Addendum #02

Date: July 2, 2021

Project: Huntington Middle School Modernization and Addition

ED001

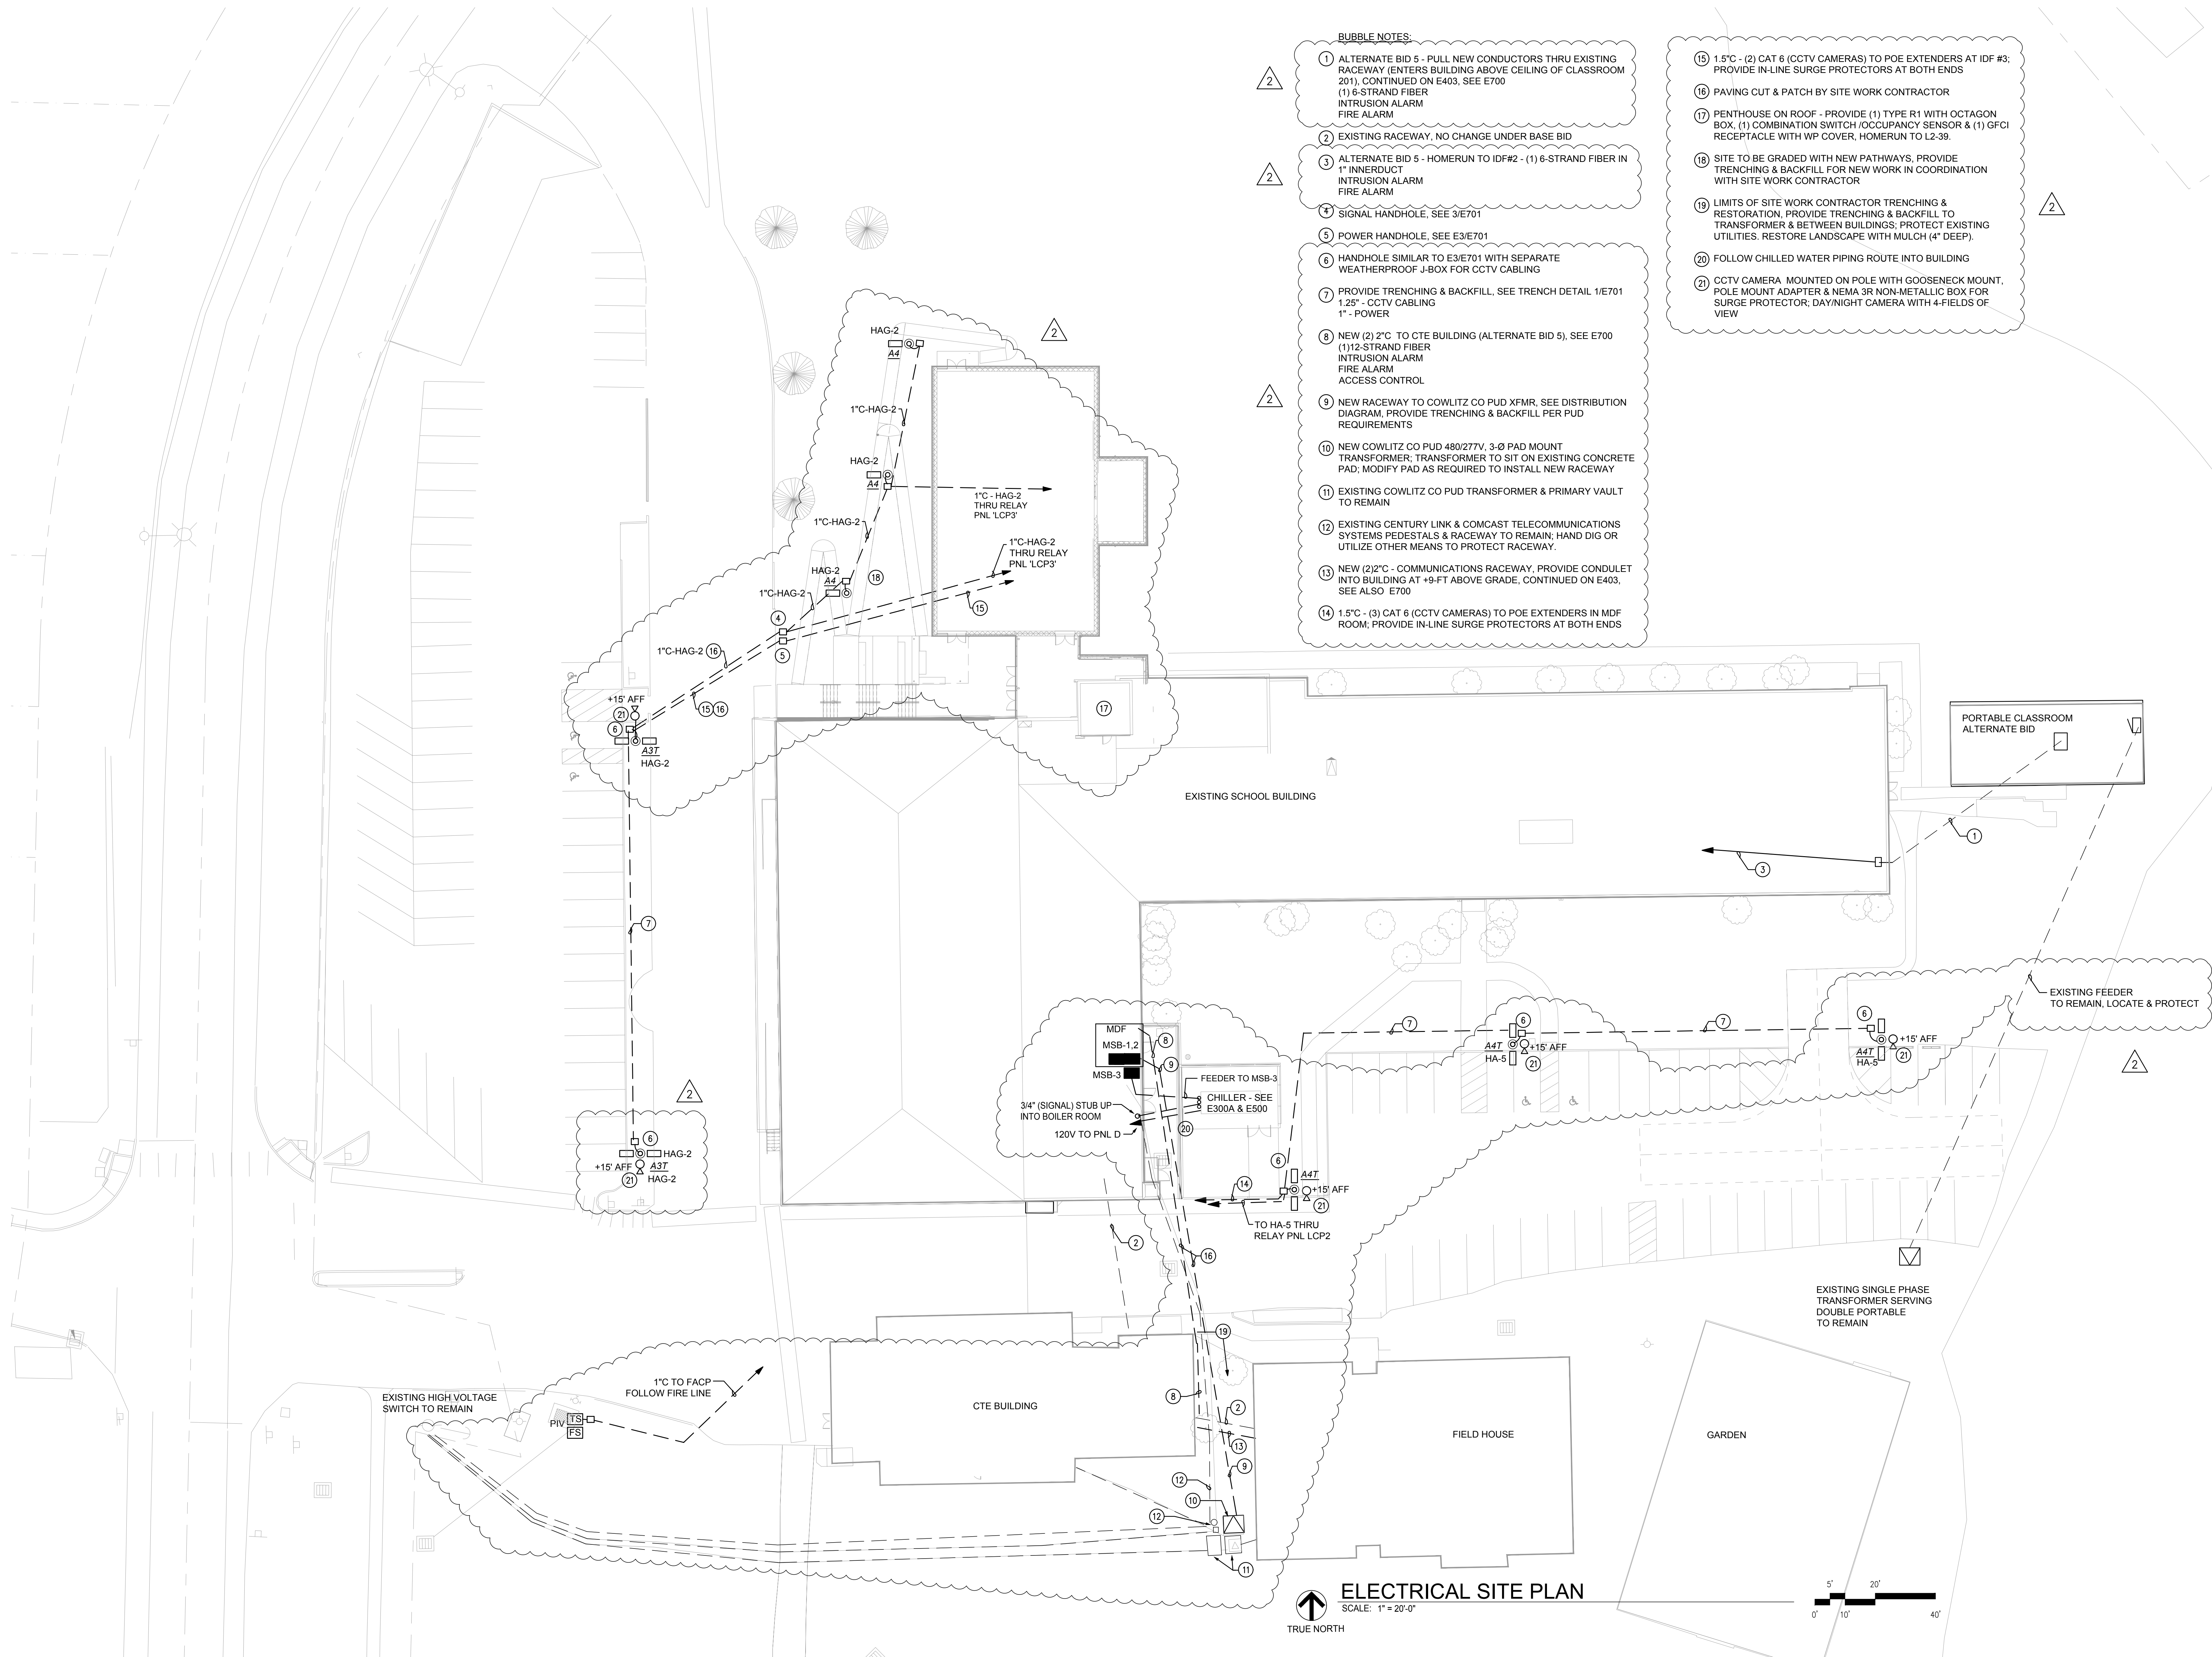
Add. #02 **Revise** per attached sheet **ED001**.

1 TRANSFORMER VAULT & BOILER ROOM
ELECTRICAL DEMOLITION PLAN
SCALE: 2' 10'
0' 5' 20'

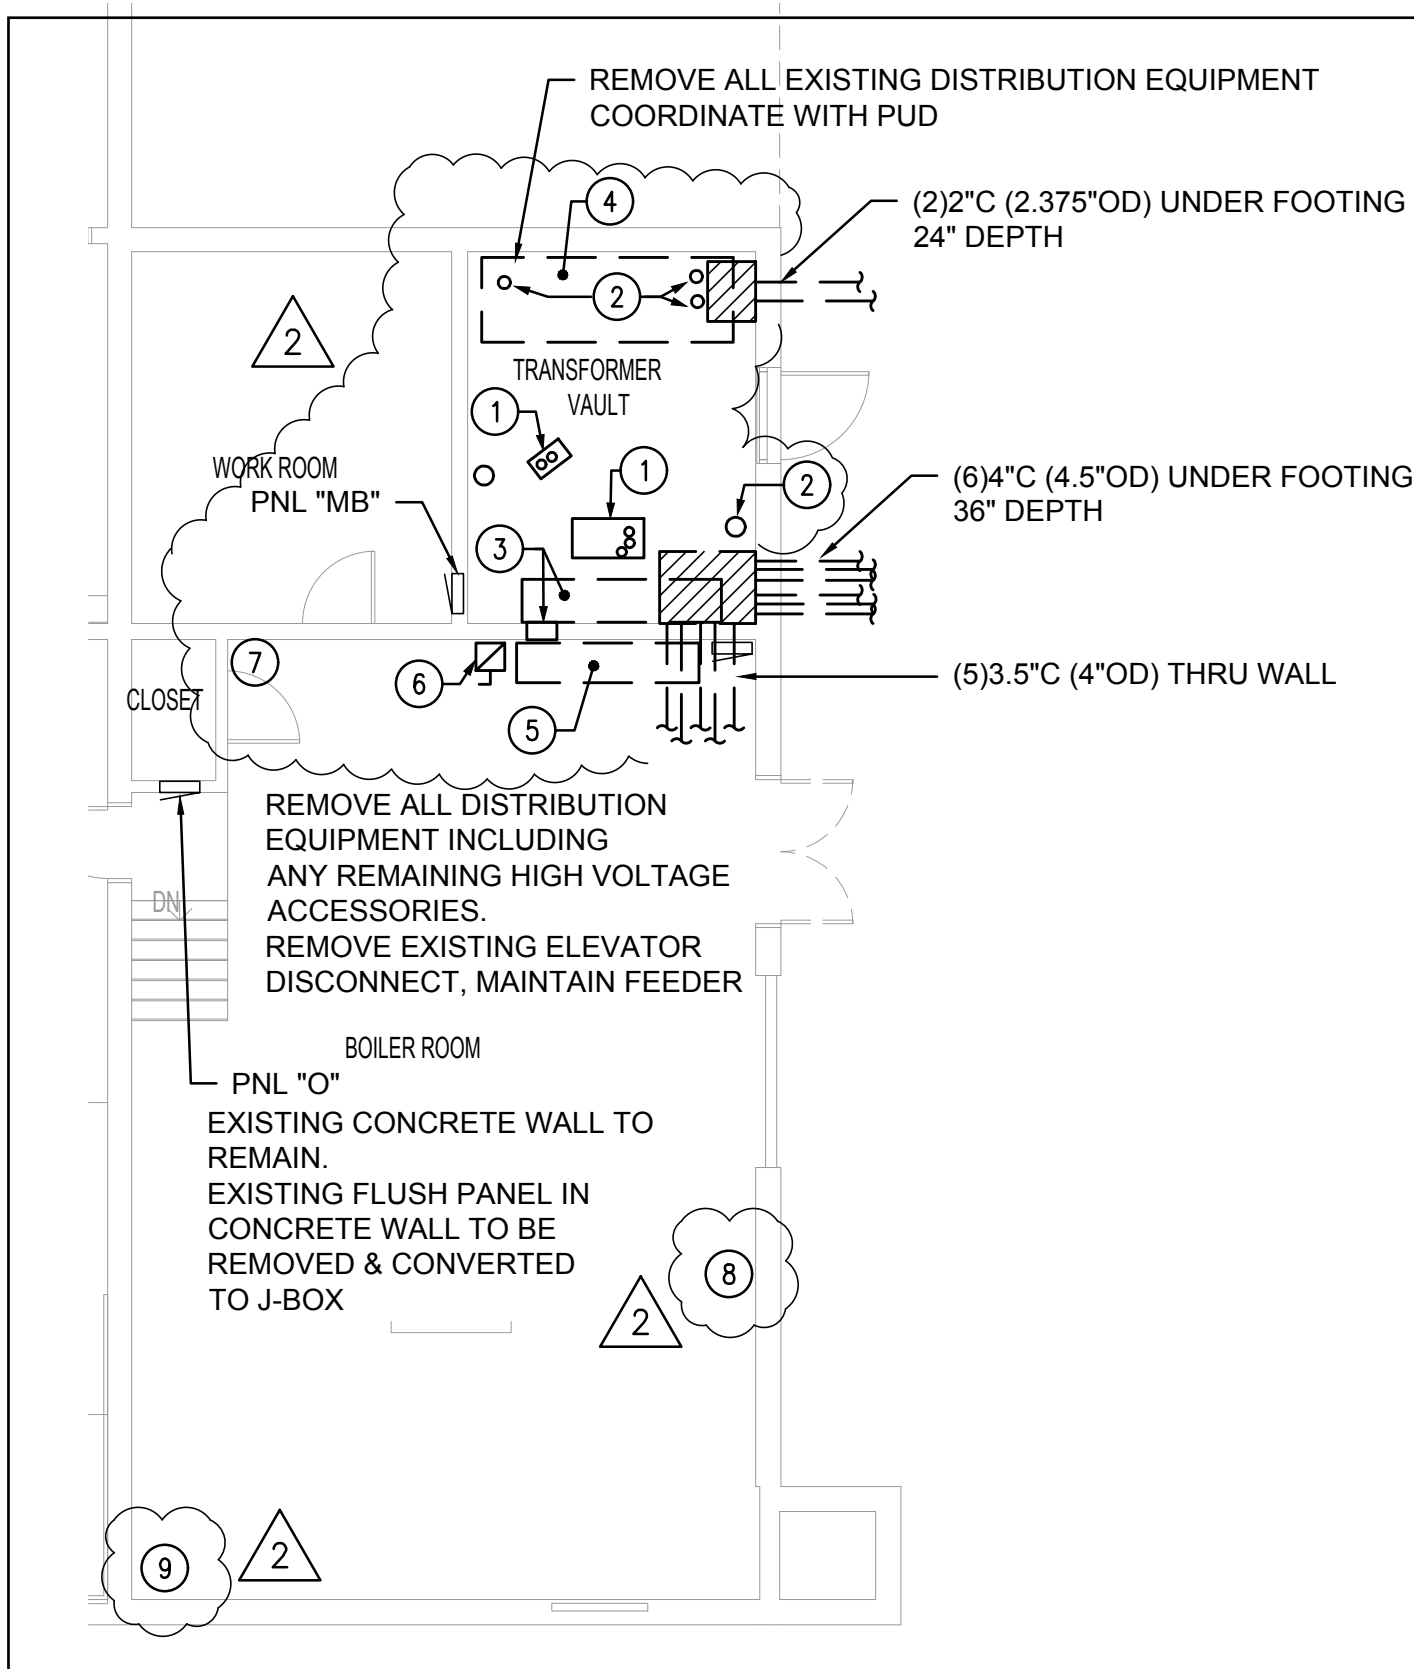
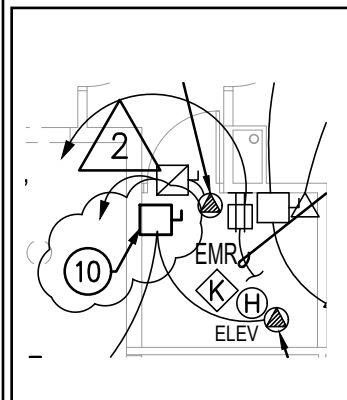
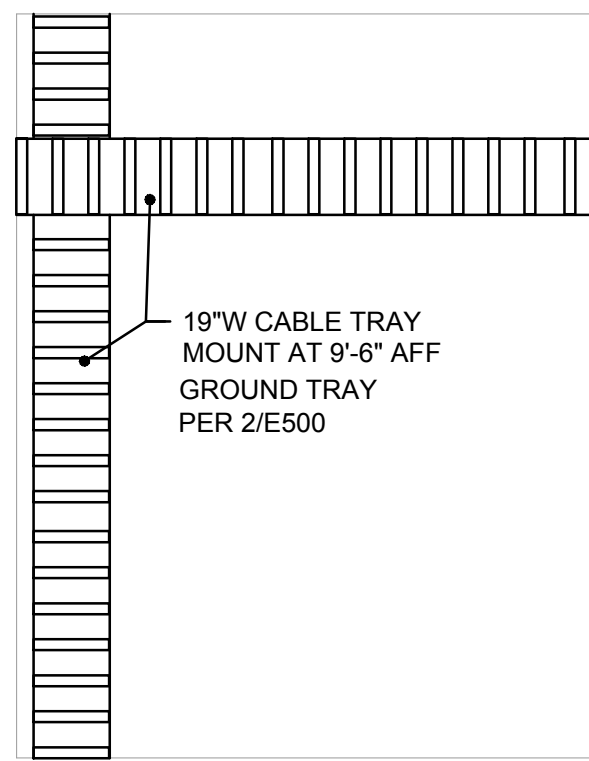
Add. #02 **Revise** Boiler Room and Transformer Vault per attached **ADE-002**.

Revise Elevator Machine Room per attached **ADE-002**.

Revise Electrical Demolition Notes per attached **ADE-002**.

Add Bubble Notes per attached **ADE-002**.

ENLARGED MDF ROOM 035

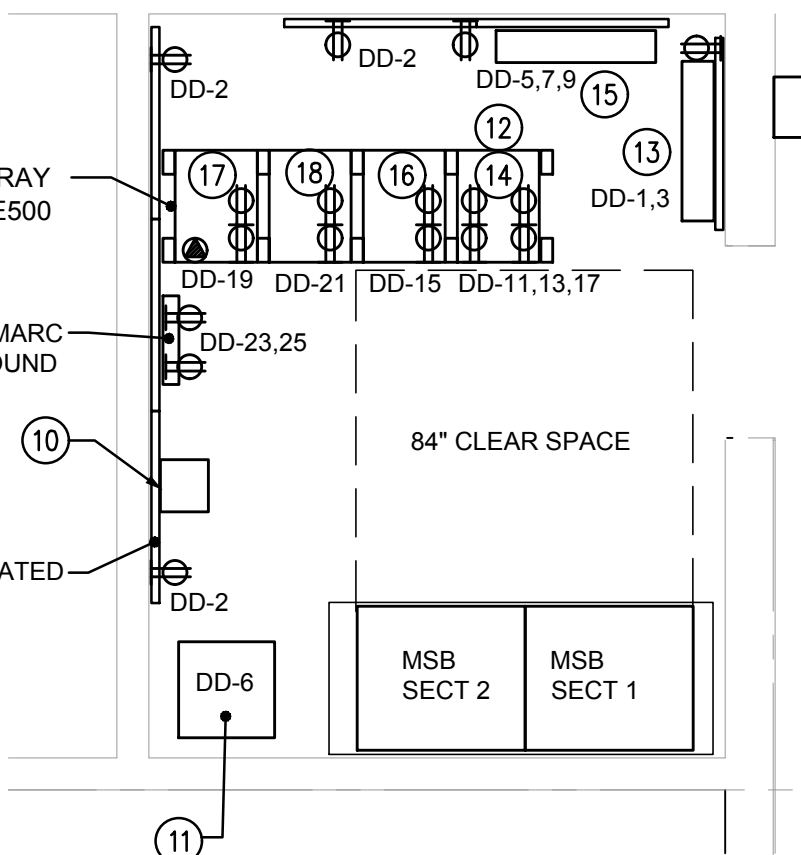
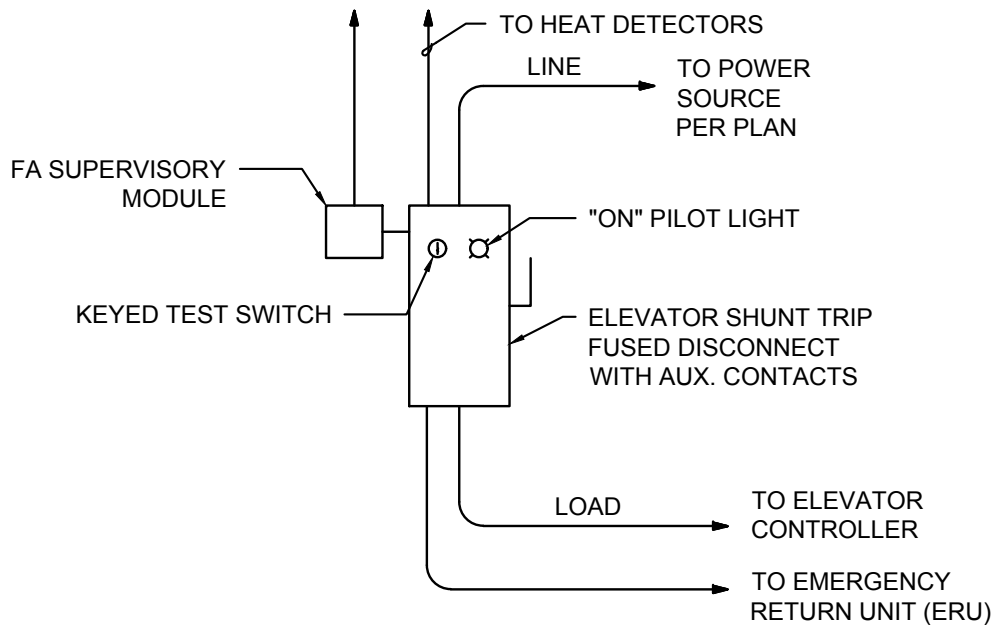
Revise MDF 035 per attached **ADE-003**.

Add. #02 **Add** Bubble Note 10 to box on west wall south of Telephone and Fiber Demarc.
Revise Bubble Note 16 at box on south side of room west of MSB SECT 2 to read: "11".

E701

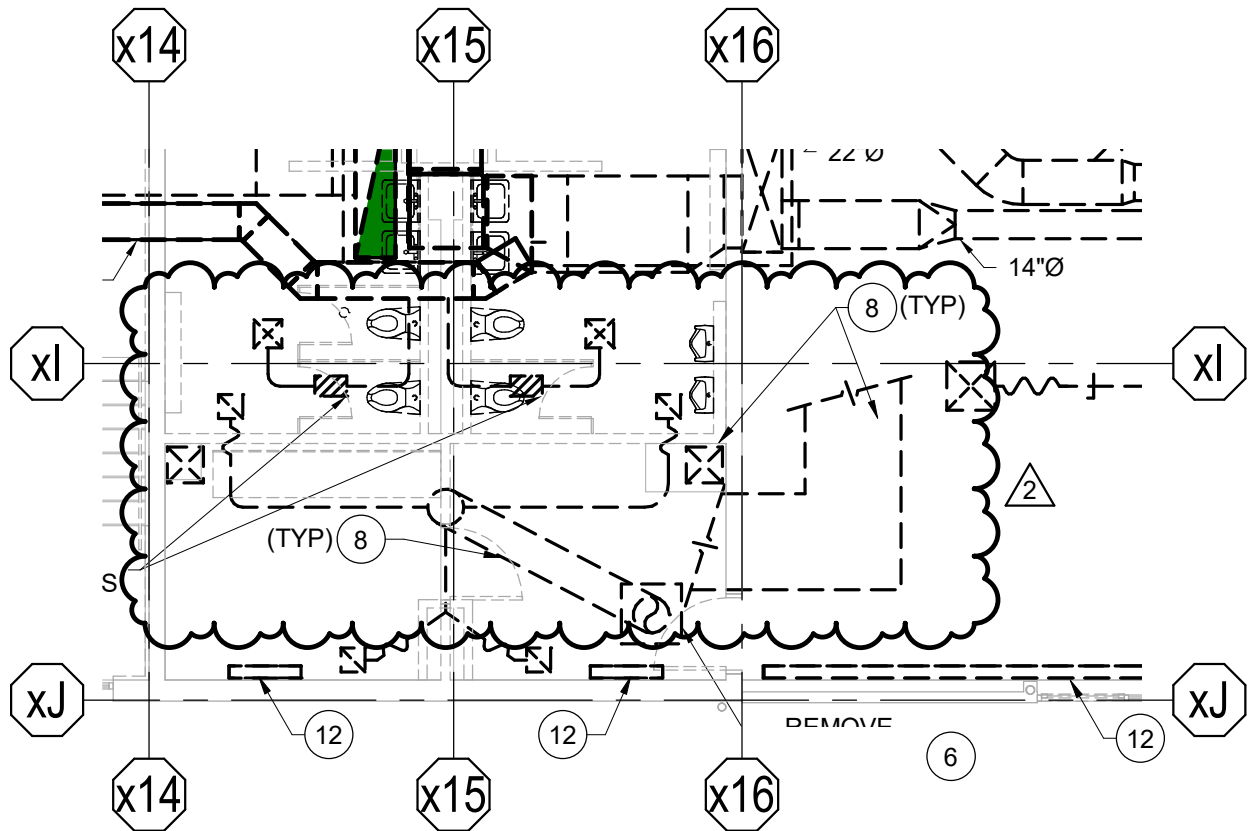
Revise Bubble Note 8 to read: “PROVIDE NEW ELEVATOR SHUNT TRIP MODULE, PROVIDE WIRING FOR INTERTIE OF ELEVATOR & FIRE SUPPRESSION SYSTEMS PER WIRING DIAGRAM 6/E701. MODIFY & EXTEND EXISTING FEEDERS.” Note: Wiring diagram to be included in this addendum per attachment **ADE-004**.

Add. #02 **Add Detail 6 – Elevator Power Riser Diagram, per attachment ADE-004.**
